MAX96724/MAX96724F/MAX96724R DEV_REV=1 (B-0A) ERRATA SHEET

Corresponds to Data sheet 19-101575; Rev 4; 1/2023 Errata

DEV_REV=1 (per reading of register 0x4C)

4) GMSL link lock times may increase if DES and SER are powered up or released from reset with significant delay relative to each other

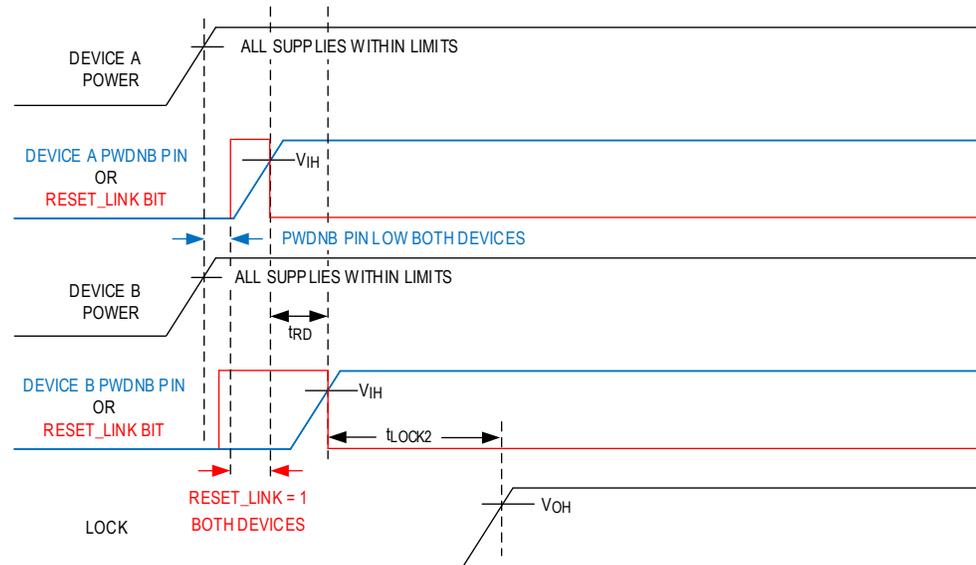
Due to timeouts in the link layer, GMSL link lock times (t_{LOCK2}) may increase above 160ms¹ (or 200ms²) if deserializer (DES) and serializer (SER) links are powered up or released from reset with more than 90ms¹ (or 70ms²) delay (t_{RD}) relative to each other. This issue applies only if the SER is released from reset first.

Note 1: The first values ($t_{\text{LOCK2}} > 160\text{ms}$ and $t_{\text{RD}} > 90\text{ms}$) refer to the links in which DES and SER devices have typical lock time $< 55\text{ms}$.

Note 2: The second set of values ($t_{\text{LOCK2}} > 200\text{ms}$ and $t_{\text{RD}} > 70\text{ms}$) are for the links where the typical lock times of either the SER or DES are greater than or equal to 55ms.

In certain configurations, devices must be programmed after the power-up (e.g. to set the link rate) and the link must be reset to trigger the configuration change. As the user-issued link resets may interrupt on-going link lock attempts, it is critical to ensure that link resets are issued on both SER and DES sides and are overlapping in time as shown on the diagram below. Without overlapping resets of both SER and DES devices, one of the devices may have to wait to complete its timeout sequence before it becomes available for the next link lock attempt. Overlapping link resets on SER and DES devices should be released within t_{RD} time window relative to each other if the SER is released from reset first, similar to the power up t_{RD} requirement.

1. Implement DES and SER programming sequence such that DES is powered up or released from link reset before SER. If link resets are used, make sure that they overlap.
2. If SER is powered up or released from link reset after DES, implement DES and SER programming sequence to power up or release DES and SER link resets within $t_{RD} < 90\text{ms}$ (or $t_{RD} < 70\text{ms}$) of each other. If link resets are used, make sure that they overlap.
3. If workarounds #1 or #2 cannot be used, contact factory for further guidance on optimizing the lock time.
